DEALER SERVICE BULLETIN

Number: DSB 13-0008

Title: SPP RBC X-13 Blower Motor
Replacement control Modules

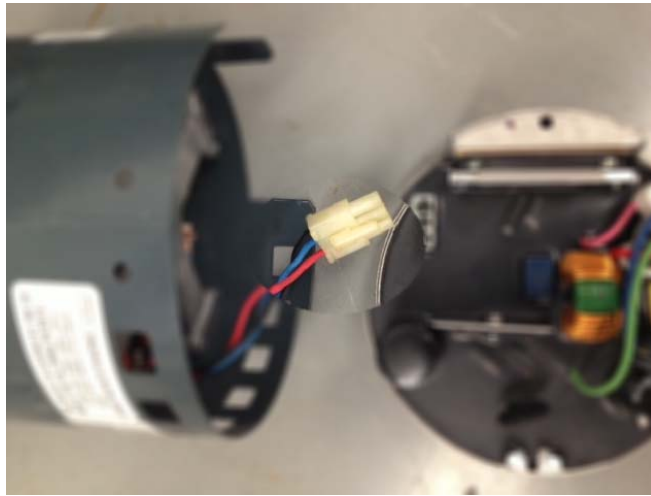
SPP X13 blower motors are experiencing a control module failure in certain operating environments.

For future claims, replace only the control section of the blower motor with a replacement control module, if available. Table 1 shows the available control module for the original blower motor. Some control modules are used with multiple motor part numbers. There is a label on each control module that references the acceptable motors with which it is compatible.

Prior to installing the replacement control module, the motor section condition needs to be verified.

- Check to see if the blower wheel spins freely.
- To check for short to ground, use an ohmmeter to measure the resistance from any one of the motor connector pins to the aluminum end plate of the motor. This resistance should be greater than 100k ohms.
- Check the motor phase-to-phase resistance between each of the leads in the three pin motor connector. The lead to lead resistance across any two leads should be less than 20 ohms. Each lead to lead resistance should be the same within +/- 10%.
